5.1. LOT 2 CAPTAIN COOK HWY, ANDREASSEN RD CRAIGLIE, ROL (1 INTO 32 RESIDENTIAL LOTS, PARK, DRAINAGE RESERVE ROAD AND BALANCE LAND)

REPORT AUTHOR(S)	Jenny Elphinstone, Senior Planning Officer
MANAGER	Paul Hoyer, Manager Environment and Planning
DEPARTMENT	Planning
PROPOSAL	Reconfiguring a Lot
APPLICANT	Port Douglas Land Developments Pty Ltd C/ Cardno (Qld) Pty Ltd PO Box 1619 Cairns Qld 4870
LOCATION OF SITE	L2 Captain Cook Hwy, Craiglie
PROPERTY	Lot 2 on SR431

Attachment 5.1.1

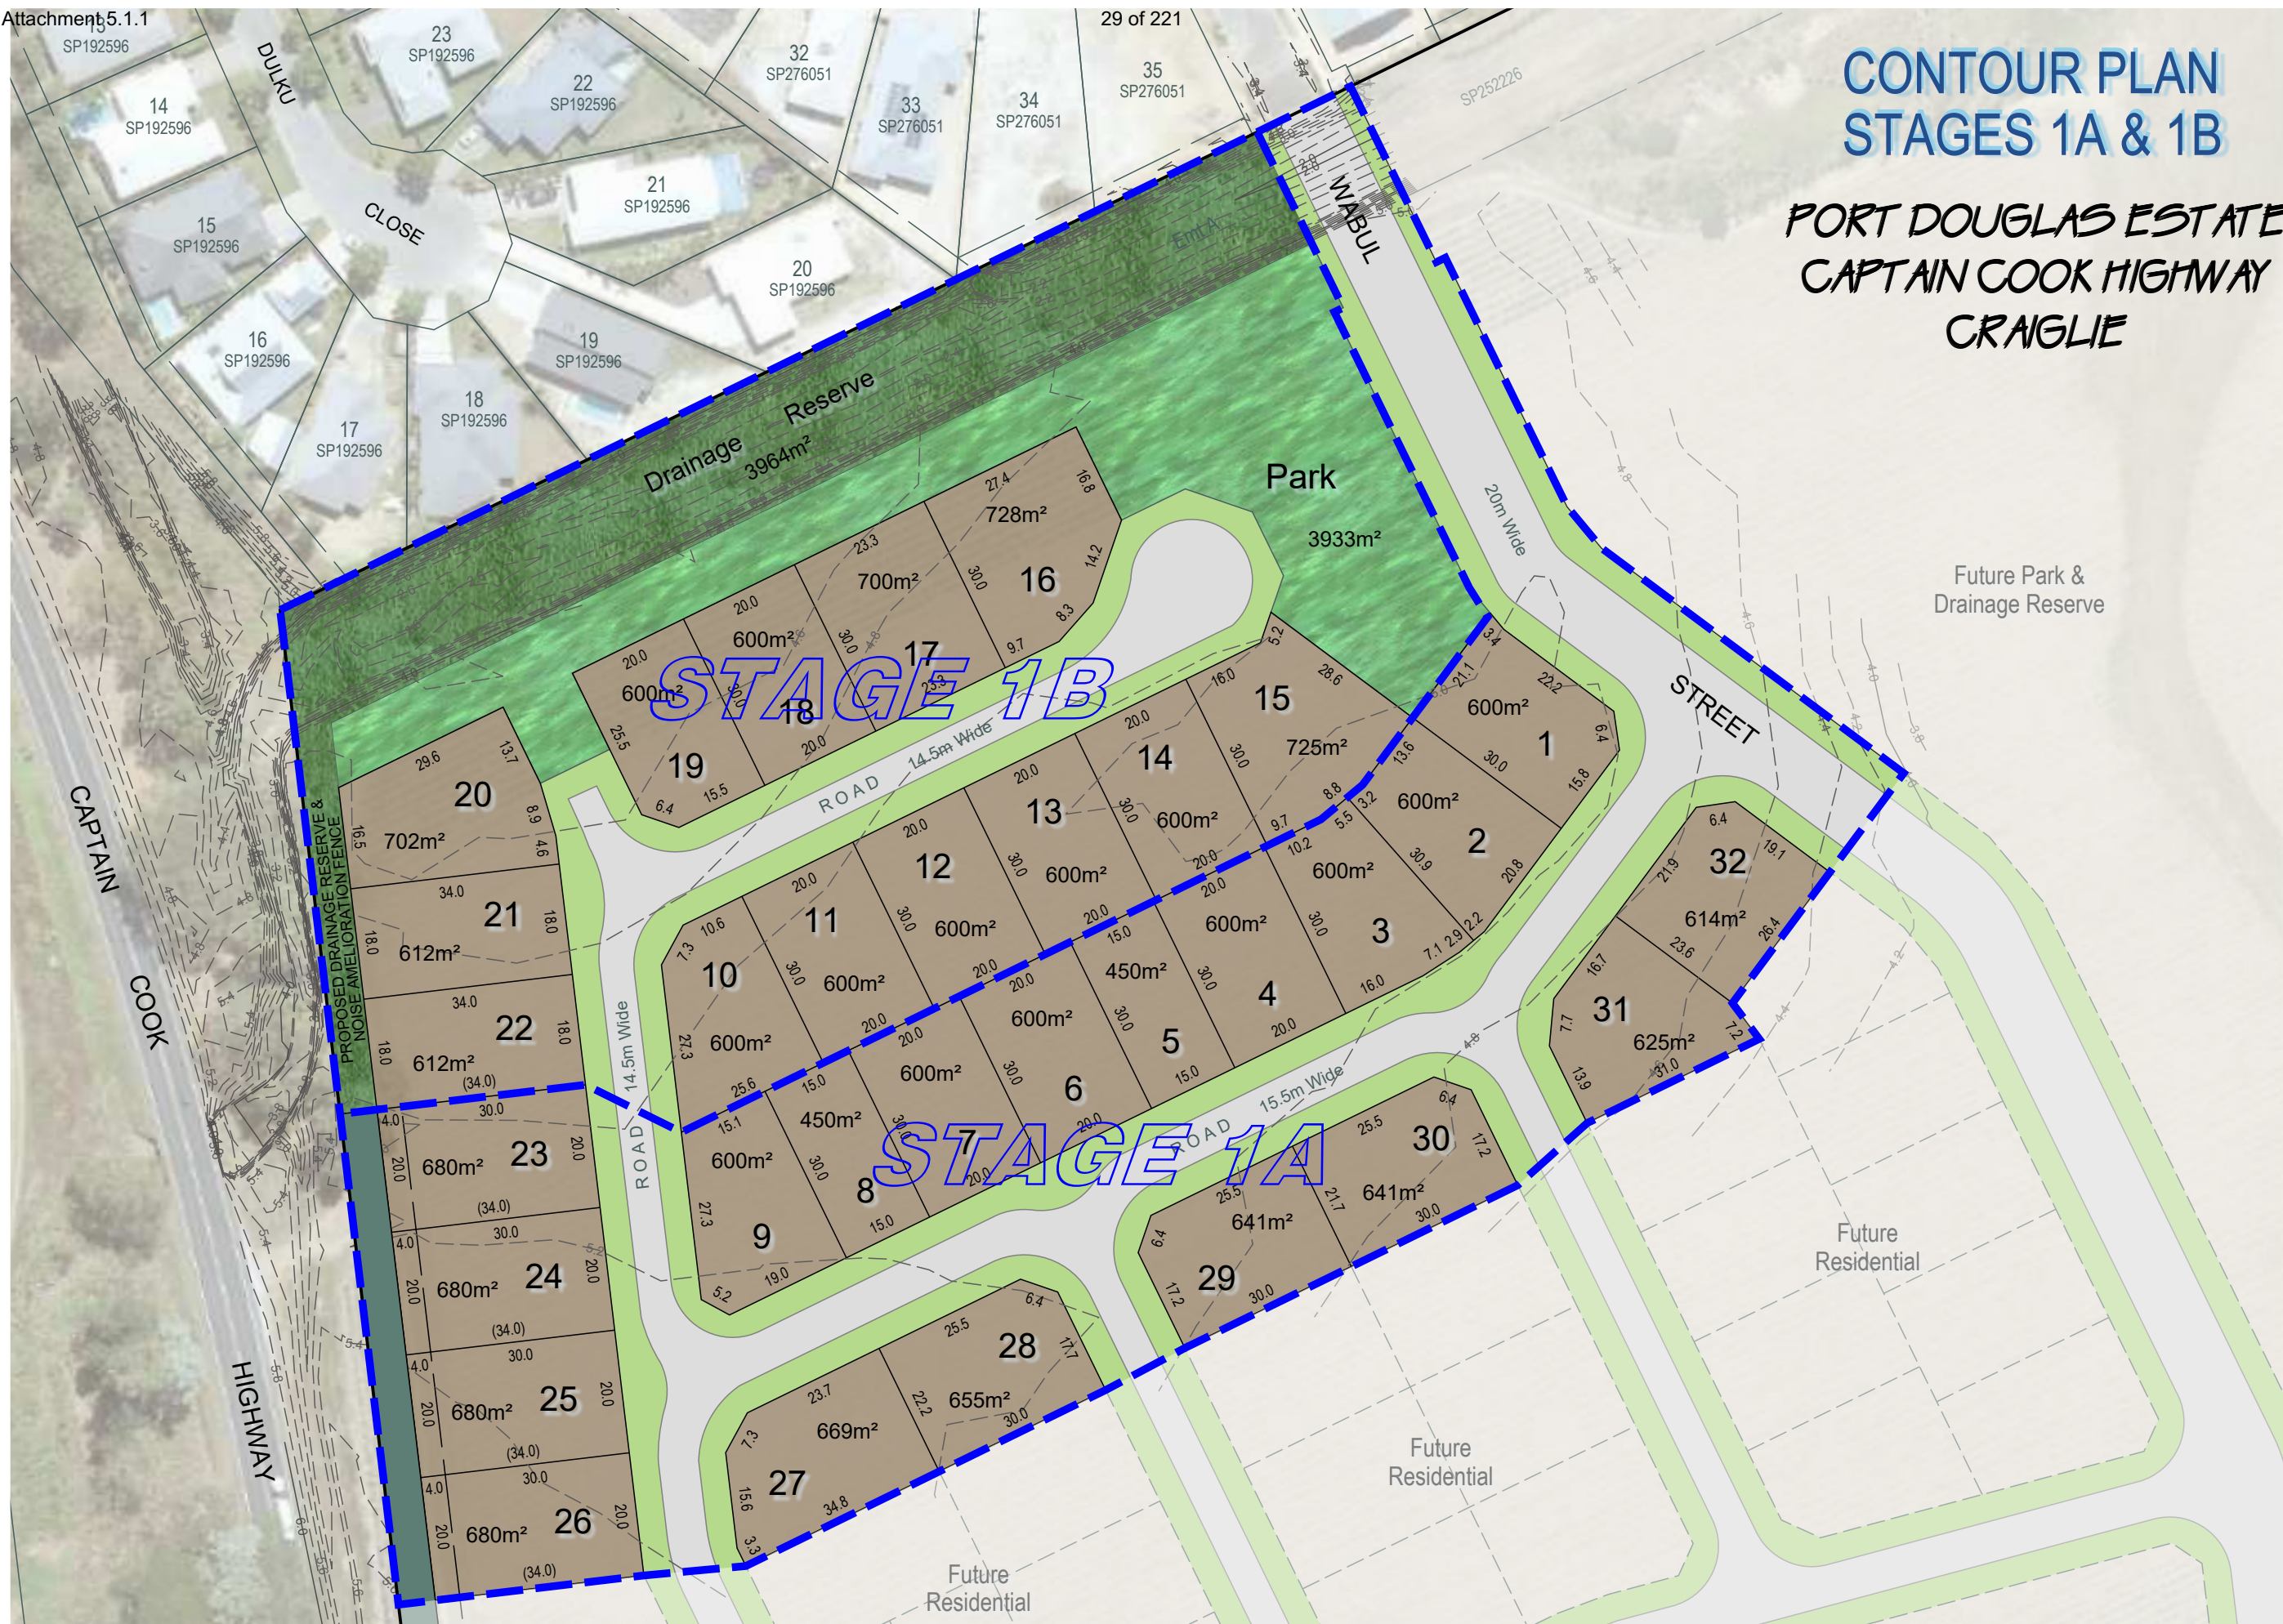
- 3. The lot layout plan must be revised and provided to the satisfaction of the Chief Executive Officer prior to the lodgement of the application for operational work, generally in accordance with the Cardno Plan No. Q184103-MP02A, dated 18 December 2018, and amended to detail:**

- a. All residential lots to have a minimum site area of 600m², a minimum road frontage of 15 metres and to be able to contain a rectangle of minimum dimensions 20 metres x 15 metres;**

- b. Replace the 'Park' at the rear of proposed Lots 16 to 20 with the description "Drainage Reserve";**
 - c. Extend the road in Stage 1B, adjacent to proposed lots 19 and 20, to the new Drainage Reserve (as outlined under condition part b above) and include a ramped profile to enable suitable access by Council vehicles to service the drainage reserve; and**

- d. Provide a ramp access and vehicle access gate to the east of the new road for access to the existing drainage easement.**

ELEVATION - WABUL STREET EXTENSION WITH CULVERT
SCALE 1:50

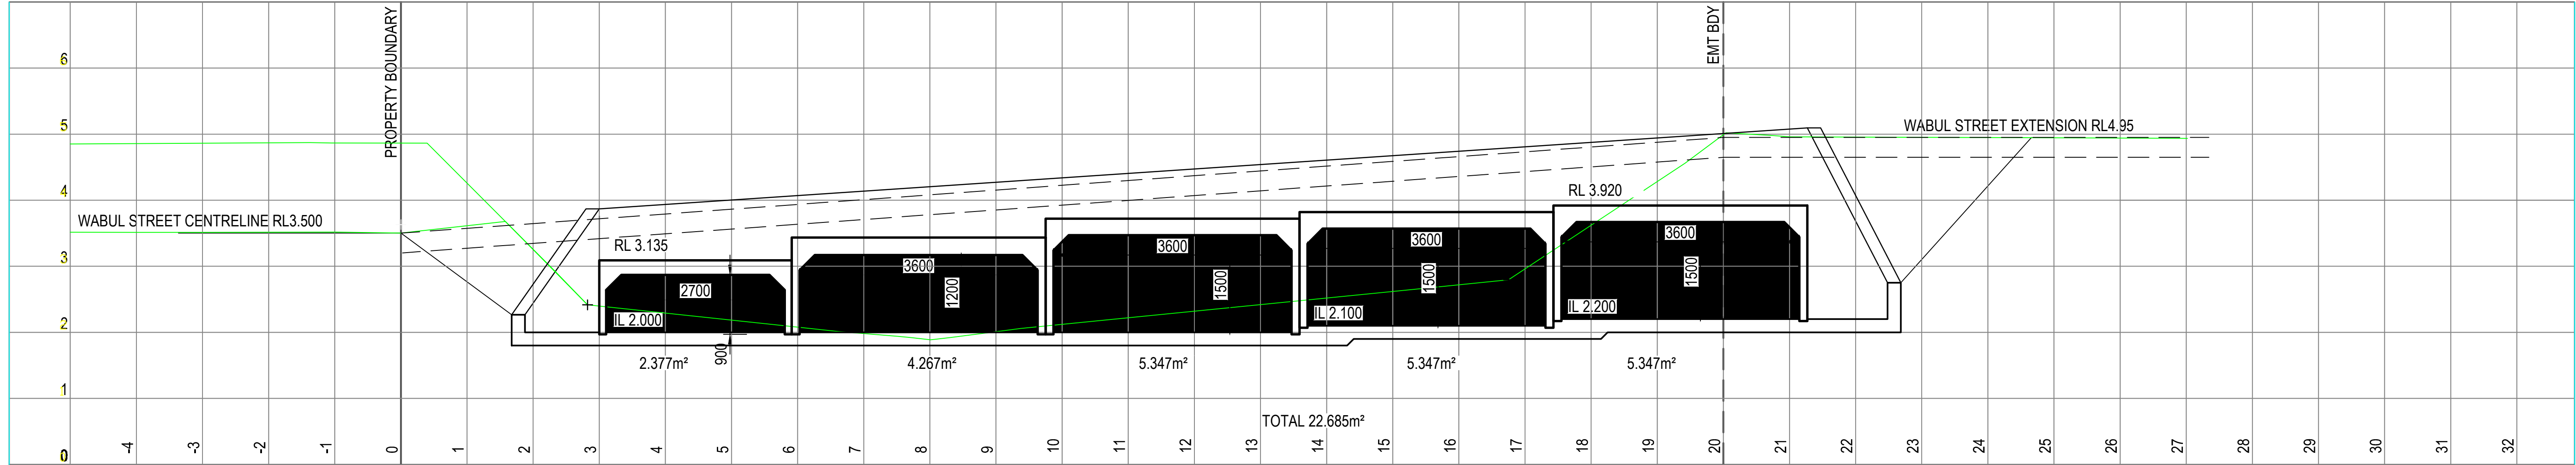
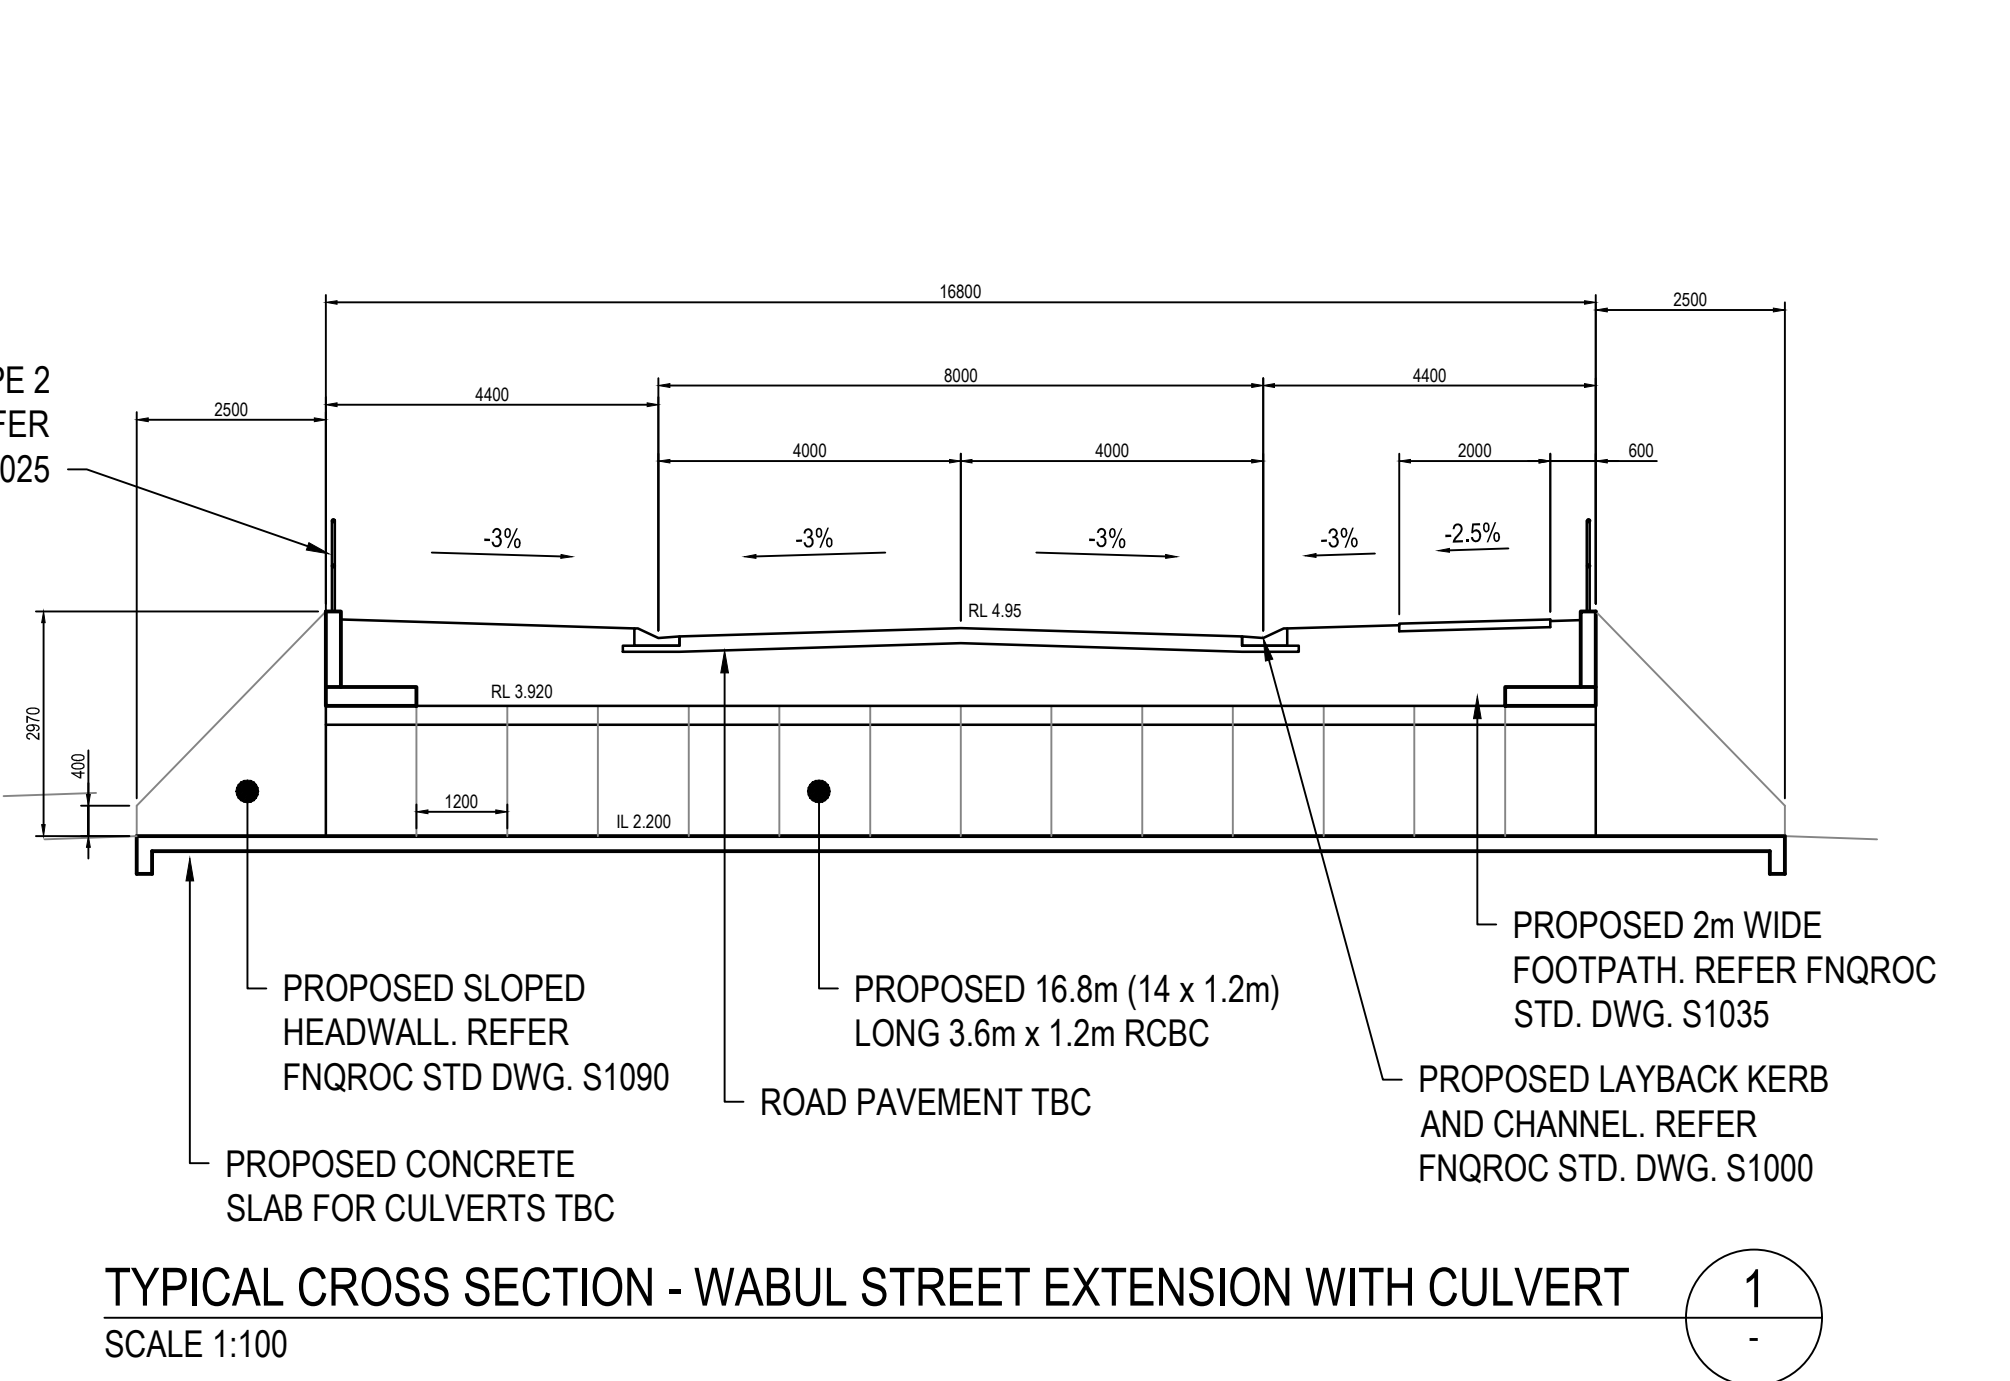
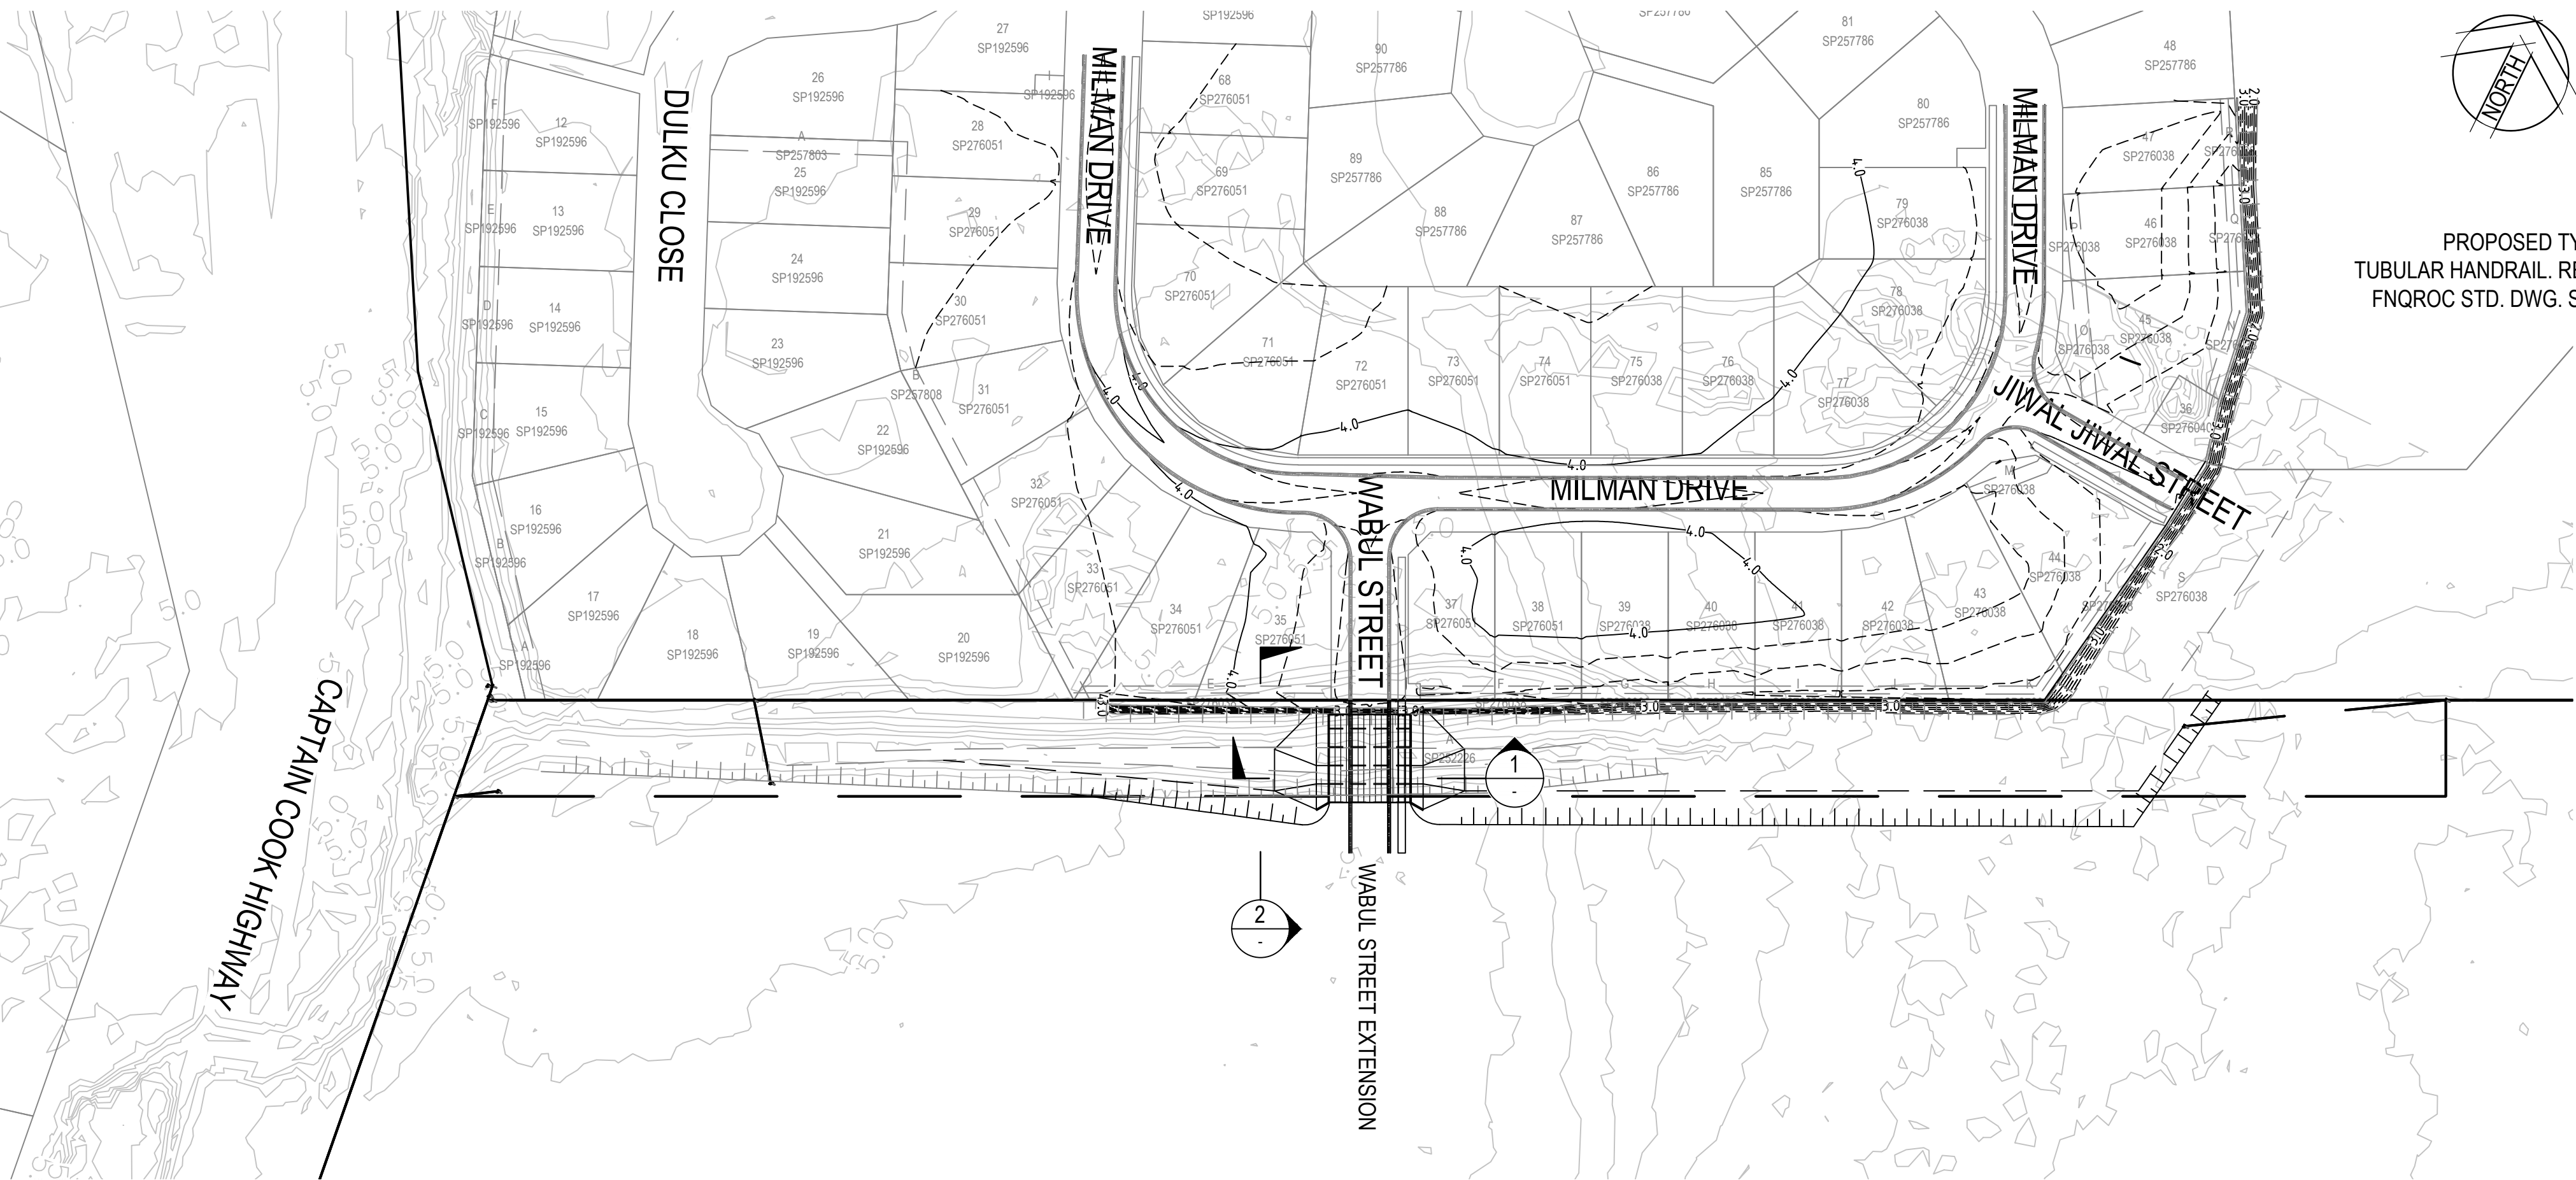
- a. Provide a full detail design and costing for the proposed culvert crossing, as detailed in Council's Local Government infrastructure plan (LGIP). The culvert size, alignment within the drainage corridor and height of the road surface above are to be confirmed with Council and supported by updated stormwater modelling prior to the lodgement of the application for Operational Works.**
- b. Construct the culvert crossing connecting to the existing road alignment in the neighbouring residential estate.**
- c. For Milman Drive/Wabul Drive link, provide a full detail design complete with costing and undertake the upgrades identified for the road system and intersection in accordance with the findings of the Road Safety Audit and Intersection Analysis.**

- d. It is unclear how the ground levels for the existing lots have been entered into the flood model and whether the current model set up excludes flow from entering existing lots. In order to properly understand the proposed drain and culverts operation and impacts, cross sections of the drain profile at regular intervals upstream and downstream from the culverts**

Any ramping of the road levels is to occur outside the alignment of the drainage corridor. Modelling of the blockage scenarios is to be confirmed.

The updated flood model and report together with an amended culvert design must be endorsed by the Chief Executive Officer prior to the issue of a Development Permit for Operational Works. All works must be carried out in accordance with the approved plan prior to the lodgement of the Survey Plan with Council for endorsement.
